Main Gate District Amendment Meeting

May 16, 2012

Main Gate District Development  
DRAFT Document

Main Gate District (UOD)  
Area 1

Figure 5 - TYPICAL CROSS SECTION AT PEDESTRIAN AREAS

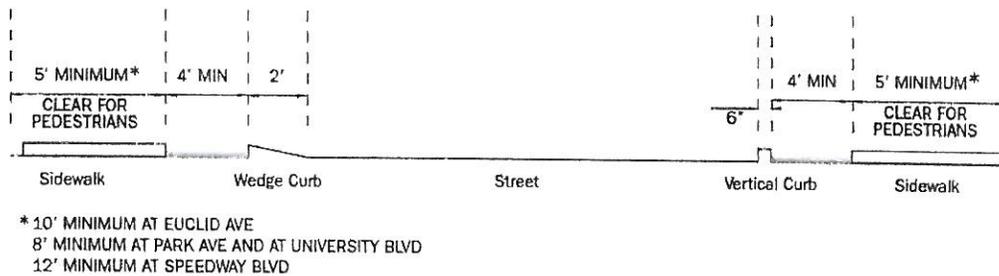
Delete

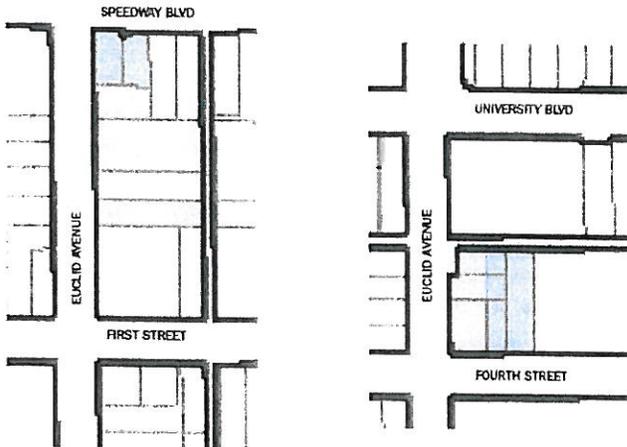
When a delisting is not occurring zoning option gives flexible option for re-use. x-ref section D

## Area 1- Speedway Subarea

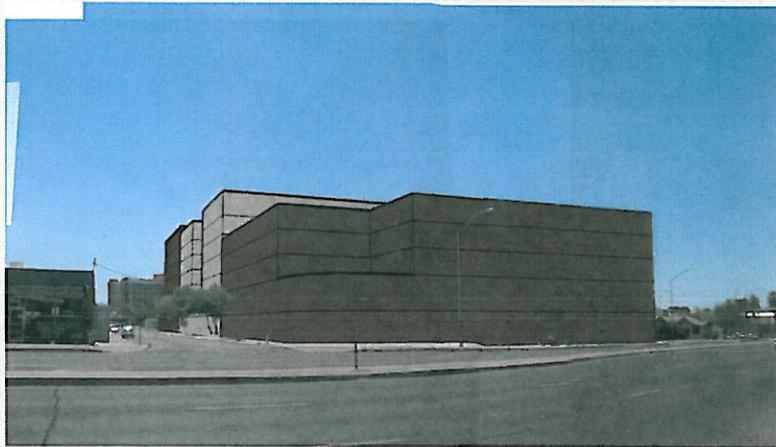
- 3 lots
- May use overlay option if there is a de-listing
- Heights are reduced to 40' and 56'
- Review by Historical Commission/DRC still occur
